**ADDENDUM NUMBER SIX****Issued: 9 February 2023****Bid Date: 14 February 2023 at 3:00 PM**

PROJECT: **GULF COAST CENTER FOR ECOTOURISM & SUSTAINABILITY**

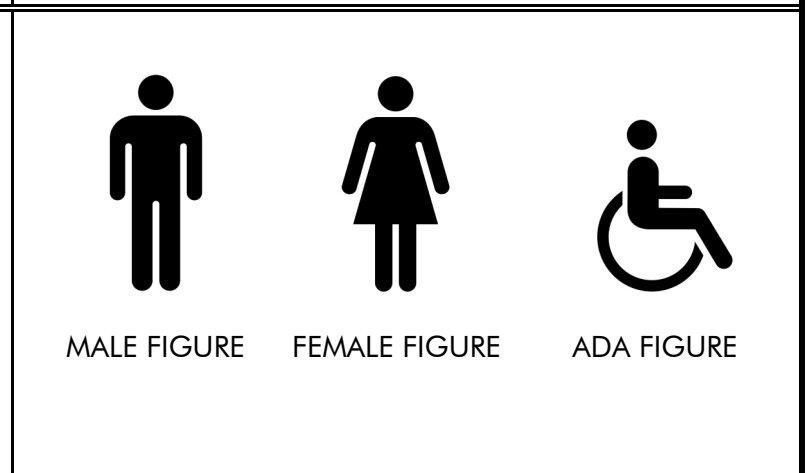
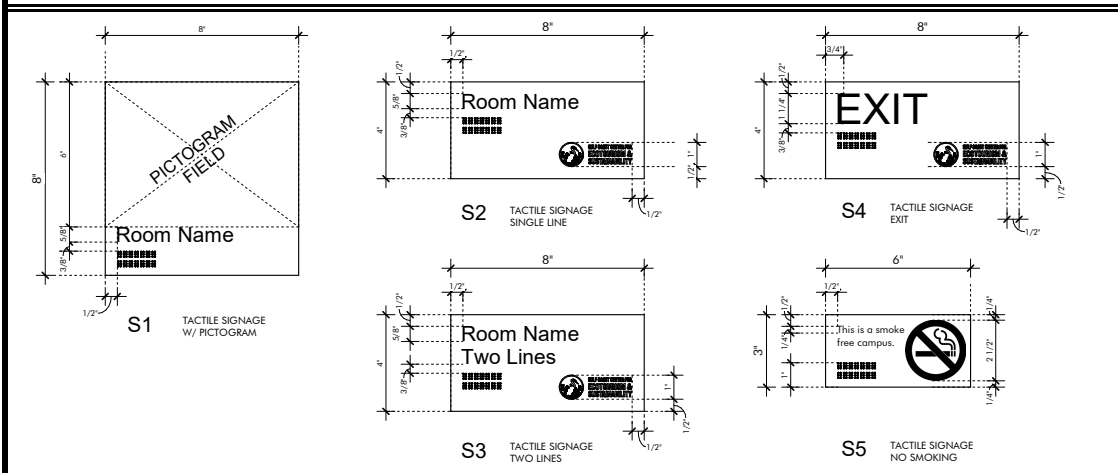
1. Attached to this addendum is a master room sign schedule for the entire campus. This schedule supersedes those in the drawing set. The conformance set of drawing after the bid will be revised to reflect this master schedule.
